Canadian Nuclear Safety Commission

Application from the CNL to amend its Chalk River Laboratories site licence to authorize the construction of a near surface disposal facility

SUBMISSION BY THE CANADIAN ENVIRONMENTAL LAW ASSOCIATION TO THE CANADIAN NUCLEAR SAFETY COMMISSION REGARDING THE FINAL ENVIRONMENTAL IMPACT STATEMENT FOR CNL'S PROPOSED NEAR SURFACE DISPOSAL FACILITY

Hearing Reference: 2022-H-07

Figure 2. Cost of Long-Term Management Options⁹⁶

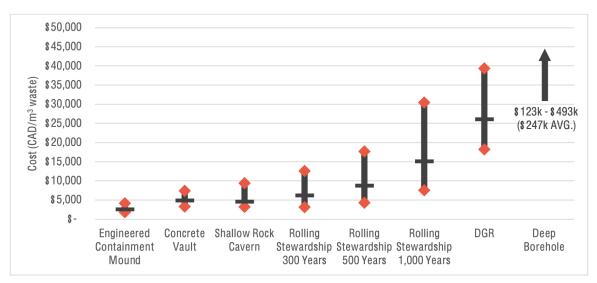
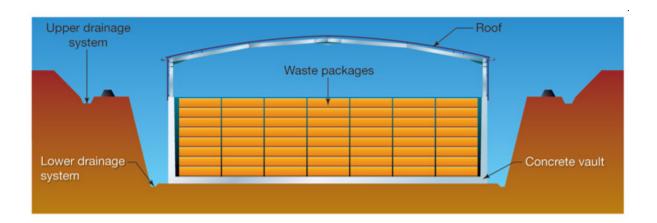
It can be seen in **Figure 2** above that the ECM is the cheapest option per m³ of waste. In CELA's view, the cheapest option is certainly inadequate for the radioactive wastes which CNL proposes to dispose of.

To provide but one example of the alternatives listed in the figure above, a concrete vault (the second least expensive option) already exists at Dounreay in Scotland - see diagram below. 97 While CELA is not tasked with assessing the suitability of the various alternatives, and although the Dounreay facility is much smaller (43,000 m³ = £110 million) and limited to LLW (maximum concentration =12 GBq of beta/gammas per tonne = 12 kBq per g), this slightly less inexpensive option clearly appears more robust and thus more suitable than an engineered landfill – i.e. the NSDF.

This example and the graph above both beg the question why the apparently cheapest option is being proposed? In particular, it suggests that more suitable alternatives were discarded due to a lack of focus on very long-term containment and protection of the environment and human health.
